APPLICATION FOR PERMIT
TYPE I MUNICIPAL SOLID WASTE FACILITY
MSW PERMIT NO. 2374
PESCADITO ENVIRONMENTAL
RESOURCE CENTER
RANCHO VIEJO WASTE MANAGEMENT, LLC
SOLID WASTE DISPOSAL FACILITY
LAREDO, WEBB COUNTY, TEXAS

September 15, 2011

**Reference: Pescadito Environmental Resource Center – Webb County
Municipal Solid Waste (MSW) – Proposed Permit No. 2374
Response to First Notice of Deficiency (NOD)
Tracking No. 14710139; CN603835489/RN106119639**

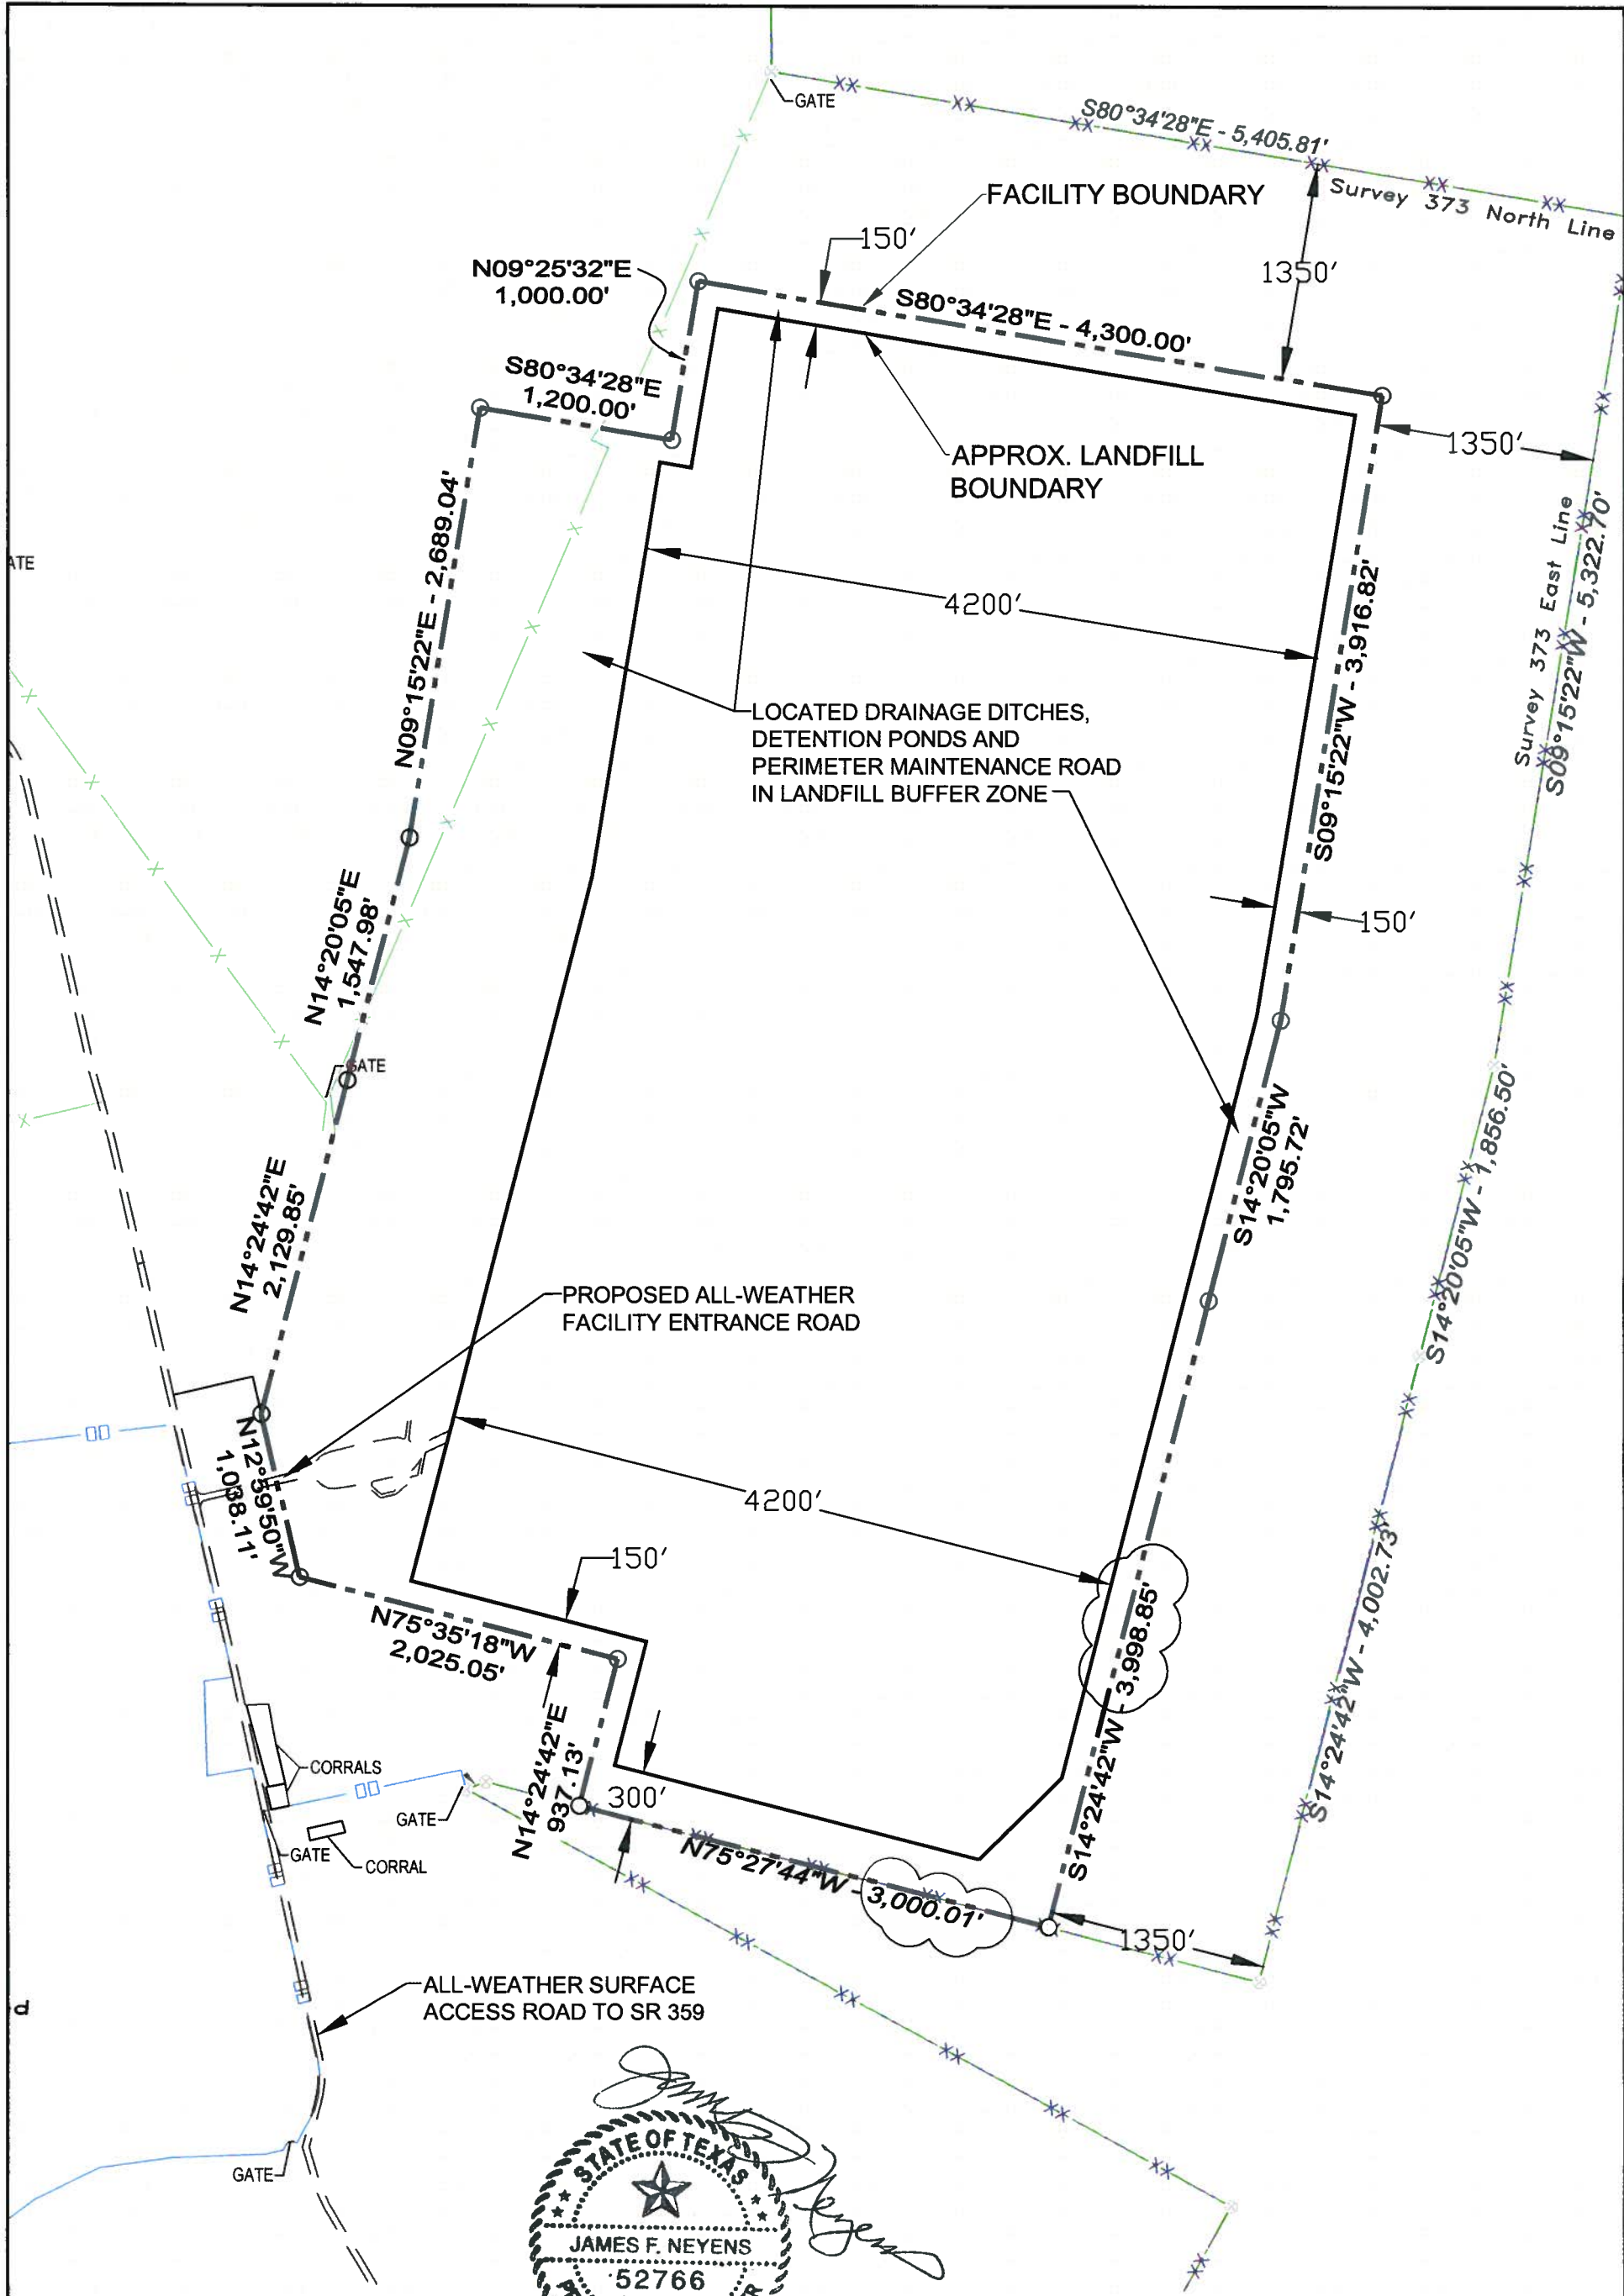
37. *Facility Layout Maps, Section 4.0. As part of the land use application, a fence along the permit boundary must be shown on the Facility Layout Maps. Please revise Figures 3 and 4 to identify where the fence will be located. Please also delete the wording in Section 4.0 about not showing the location of the fence until Parts III and IV are submitted. (30 TAC §330.61(d)(6)).*

We have added a fence to the Facility Layout Maps. Figures 3 and 4 now reflect where

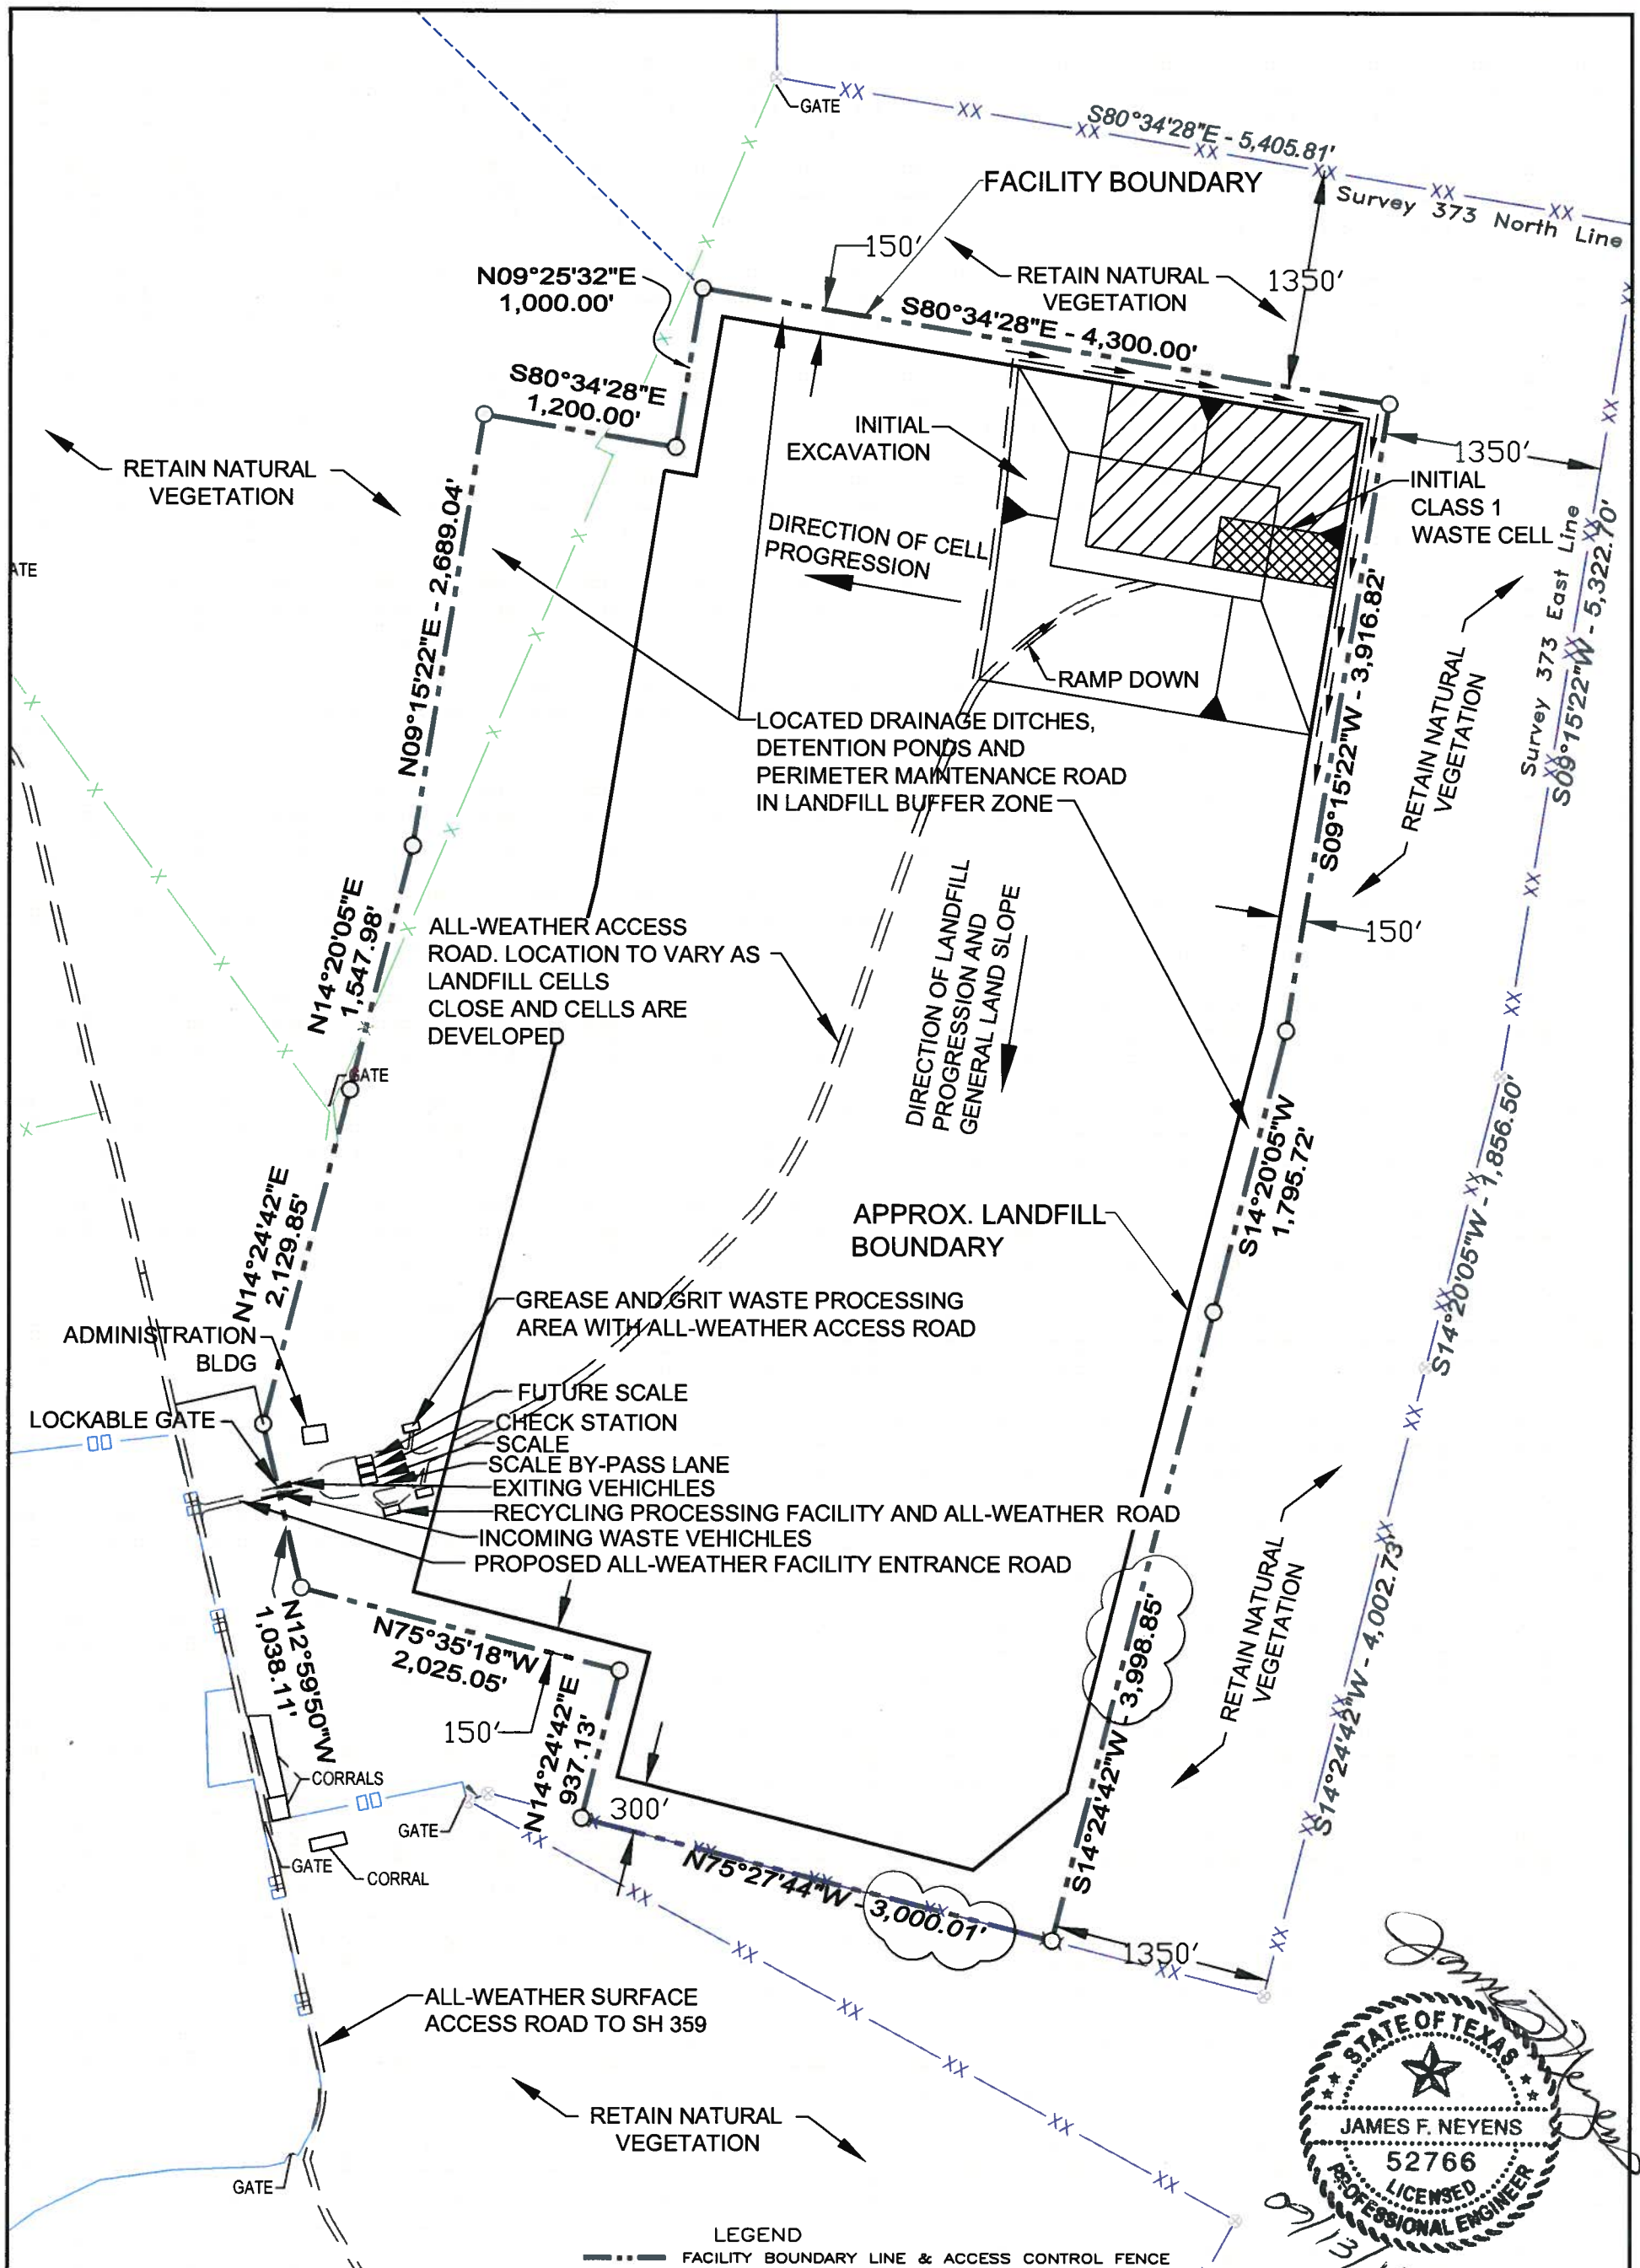
35. *Facility Layout Maps, Section 4.0. Please identify roads to be associated with the Type V grease and grit trap operation, the recycling operation, and the Class I cell. Please provide a note on Figure 4 or in Section 4.0 indicating that the landfill interior road will vary as each cell is filled and each new cell is constructed. (30 TAC §330.61(d)(2)).*

42. *Facility Layout Maps, Section 4.0. Please identify dimensions of landfill sectors on Figure 4. The figure provided to show general cell construction (northwest corner of the landfill) would be adequate for this purpose if it were an inset to Figure 4 or an additional drawing, not within the landfill boundary, and using typical cell dimensions or a range of cell dimensions, etc. (30 TAC §330.61(d)(9)(D)).*

We have provided the general location of all landfill sectors in Figure 4.

We have added proposed dimensions of landfill sectors in Figure 4.
